**Administrative Committee of the European Agreement  
Concerning the International Carriage of Dangerous  
Goods by Inland Waterways (ADN)**

**European Agreement concerning the International Carriage  
of Dangerous Goods by Inland Waterways (ADN)****Draft amendments to the Regulations annexed to ADN\***

**Zone Classification Legend:**

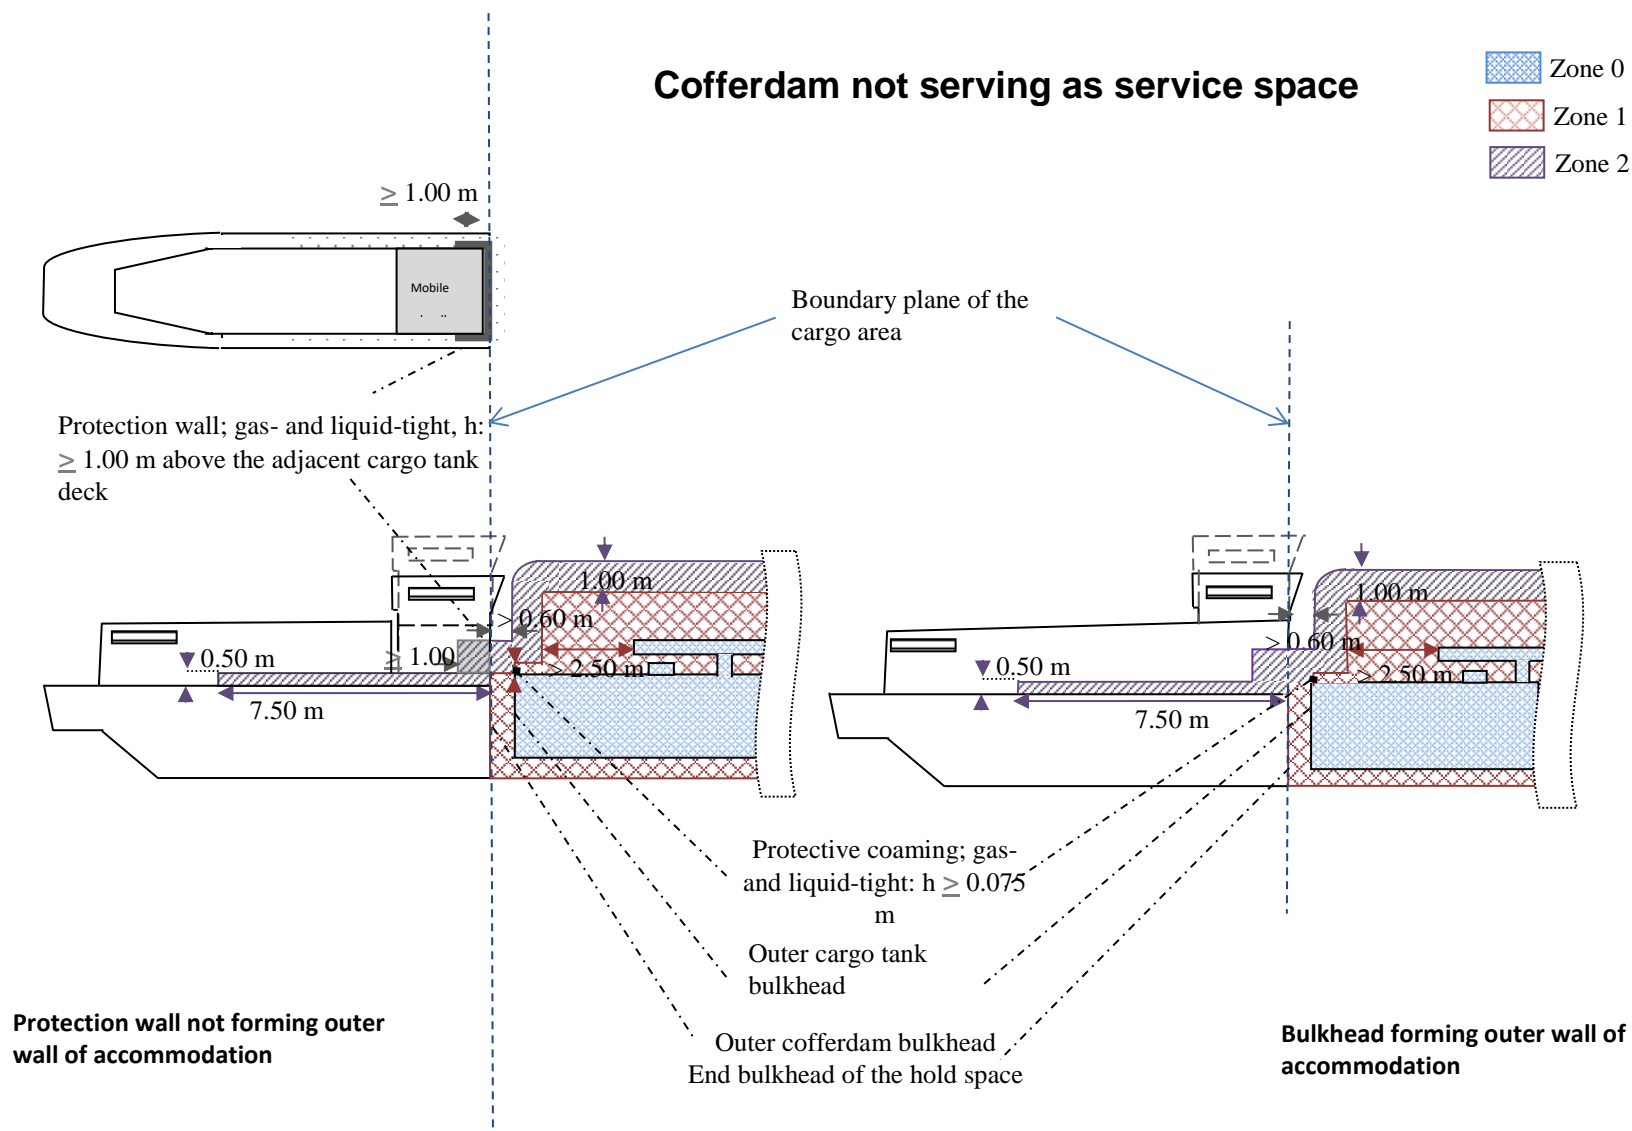
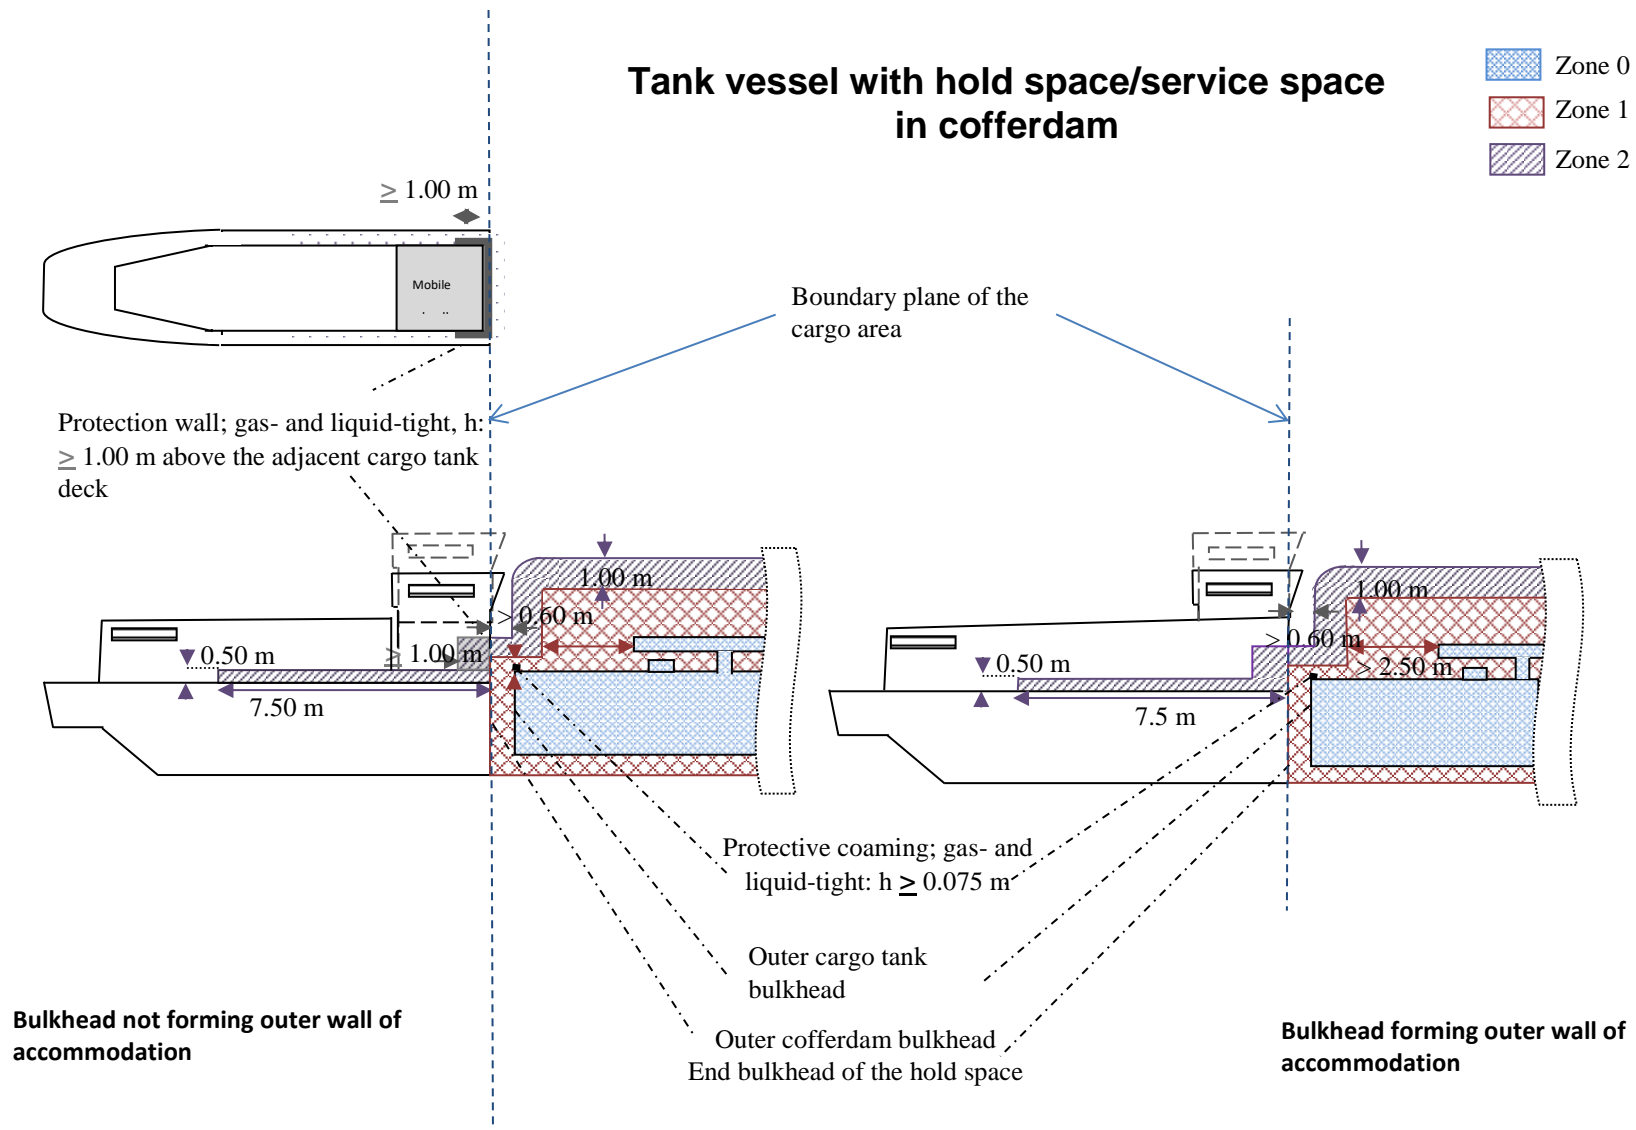
- All spaces located below deck in the cargo area not part of zone 0.
- Closed spaces on deck within the cargo area.
- The deck in the cargo area over the entire width of the vessel to the outer cofferdam bulkheads.
- Up to a distance of at least 1.60 m to the “boundary planes of the cargo area”, the height above the deck is 2.50 m, but at least 1.50 m above the highest piping carrying cargoes or cargo vapours.

If the ship is built with hold spaces or a cofferdam/part of a cofferdam is arranged as a service space, the adjacent height (fore and aft) to the “boundary plane of the cargo area” is 1.00 m above deck (see diagram).

- On the deck in the cargo area, a zone extending 1.00 m upwards and sideways longitudinally from zone 1.
- On the fore deck and the aft deck, an area 7.50 m in length across the entire width of the vessel and adjacent to the “boundary plane of the cargo area”. Between the lateral side of the vessel and the protection wall, the length and height of this area equals the dimensions of the lateral side of the protection wall. Elsewhere, the height in zone 2 is 0.50 m.

- Protection wall; gas and liquid tight,  $h \geq 1.00$  m above the adjacent cargo tank deck.
- Mobile hatchway.
- High velocity vent valve.
- Outer cargo tank bulkhead.
- Outer cofferdam bulkhead.
- End bulkhead of the hold space.
- Protective coaming, gas- and liquid-tight:  $h \geq 0.075$  m.
- Boundary plane of the cargo area.
- Boundary plane of the cargo area.

**Figure 2.2.8.1.6.1: Step-wise approach to classify and assign packing group of corrosive mixtures**

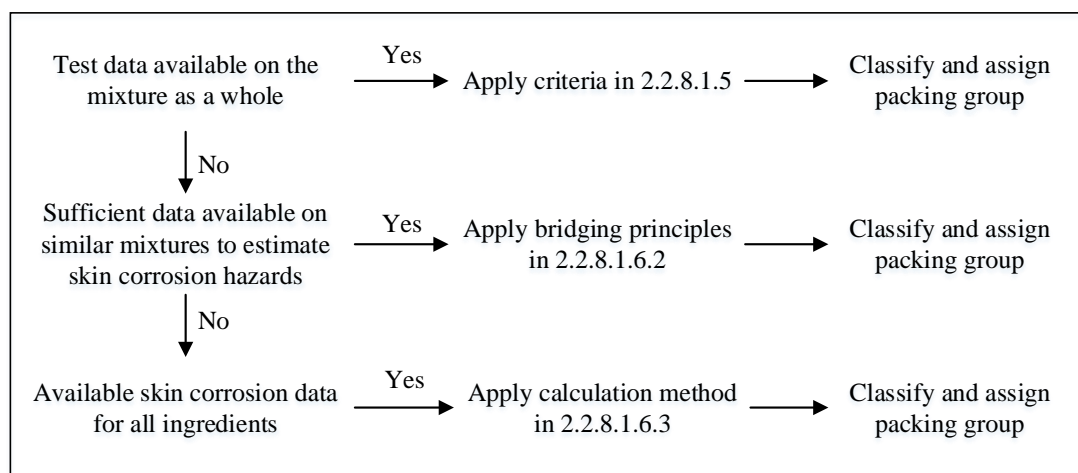
2.2.8.1.6.1 General provisions

For mixtures it is necessary to obtain or derive information that allows the criteria to be applied to the mixture for the purpose of classification and assignment of packing groups. The approach to classification and assignment of packing groups is tiered, and is dependent upon the amount of information available for the mixture itself, for similar mixtures and/or for its ingredients. The flow chart of Figure 2.2.8.1.6.1 below outlines the process to be followed:

**Figure 2.2.8.1.6.3: Calculation method**

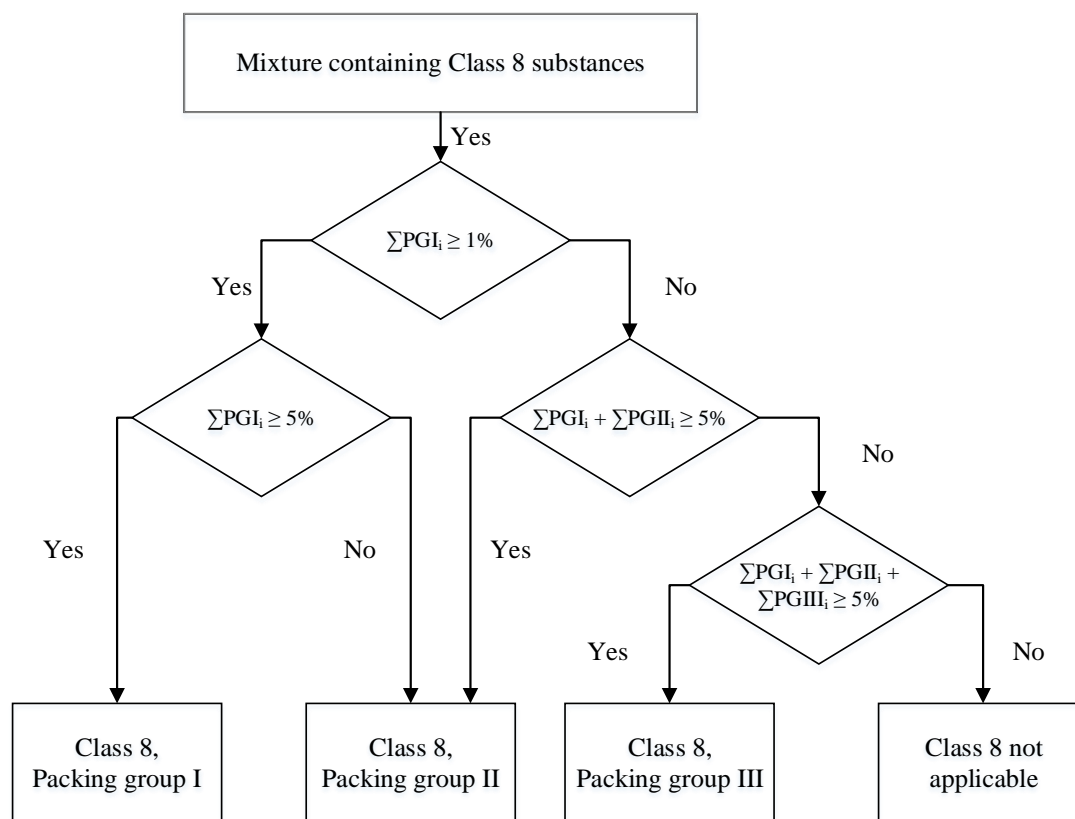
2.2.8.1.6.3.3 To determine whether a mixture containing corrosive substances shall be considered a corrosive mixture and to assign a packing group, the calculation method in the flow chart in Figure 2.2.8.1.6.3 shall be applied.

2.2.8.1.6.3.4 When a specific concentration limit (SCL) is assigned to a substance following its entry in Table A of Chapter 3.2 or in a special provision, this limit shall be used instead of the generic concentration limits (GCL). This appears where 1% is used in the first step for the assessment of the packing group I substances, and where 5% is used for the other steps respectively in Figure 2.2.8.1.6.3.

The criterion for a packing group is fulfilled when the result of the calculation is  $\geq 1$ . The generic concentration limits to be used for the evaluation in each step of the calculation method are those found in Figure 2.2.8.1.6.3.
